Y BRYN WIND FARM, SOUTH WALES:
PROPOSAL FOR ALTERNATIVE LIGHTING
SCHEME

Report No.21/972/NPC/1

1.1 This document sets out a request to the Civil Aviation Authority for permission to provide an alternative lighting scheme on the proposed Y Bryn wind farm, South Wales, under the terms of Article 222(6) and 222(7) of the Air Navigation Order.

Figure 1: Proposed Y Bryn wind farm lighting scheme

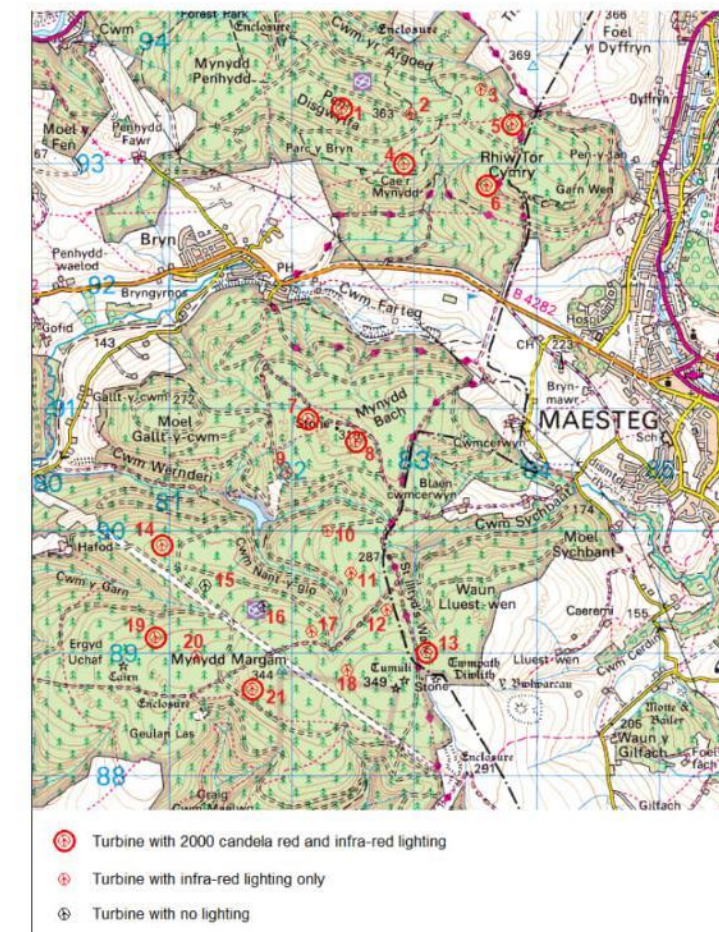
9.3 The Wales Air Ambulance suggested lighting scheme was then used as a basis for consultation with other stakeholders. In addition to the suggested visible lighting layout, it was proposed to fit all turbines except T15, 16 and 17 with infra-red lighting, in order to clearly identify the wind farm perimeter to NVG-equipped aircrew. This modified scheme was then submitted to Bristow SAR and NPAS for consideration.
